**PLANNING DIVISION REPORT
DEPARTMENT OF PLANNING AND COMMUNITY
AND ECONOMIC DEVELOPMENT
October 6, 2008**

RE: LD. # 12153, Conditional Use Application – 610 John Nolen Drive

SUBJECT: 610 John Nolen Drive Conditional Use

NORTH BUILDING ELEVATION
SCALE 1/8" = 1'-0"

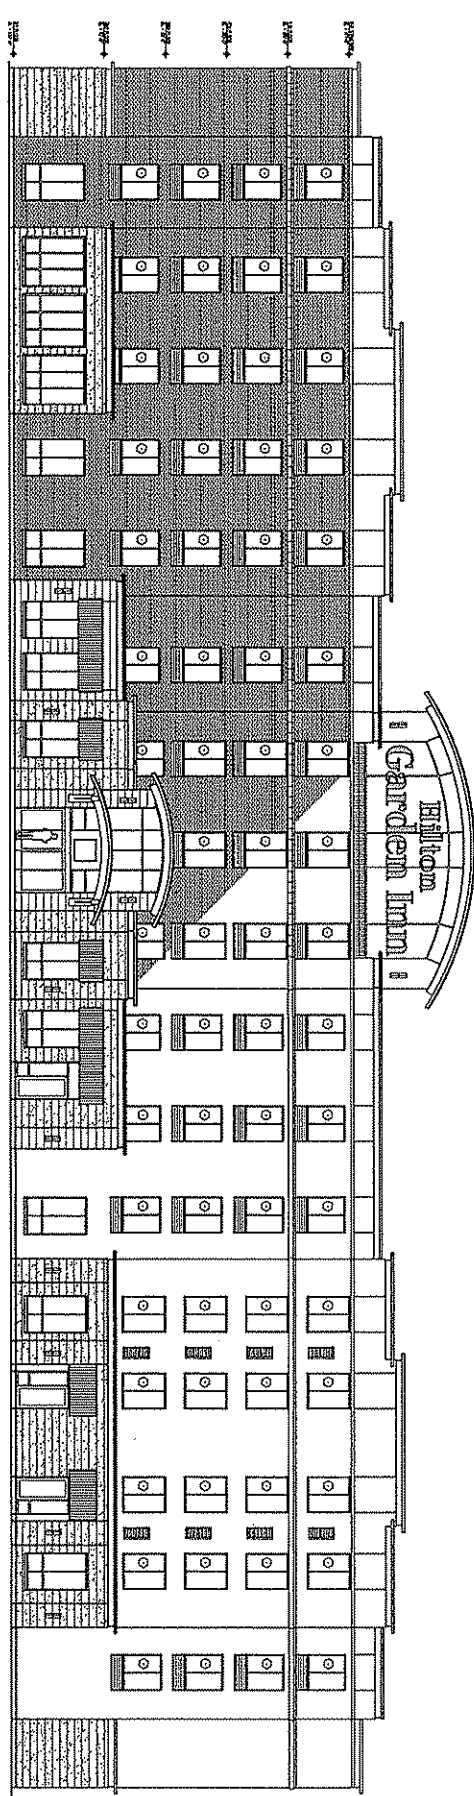
The Commission noted that the elevations showing the signs on the sides of the building had not been revised to show the belt course moved up one story to match the front elevation. The Commission discussed whether the signage on the side elevations should be centered, or offset closer to the street.

- Good.
- Side signs oversized for space.
- Signage at end of building needs better composition.
- Minor, but welcome, improvements.
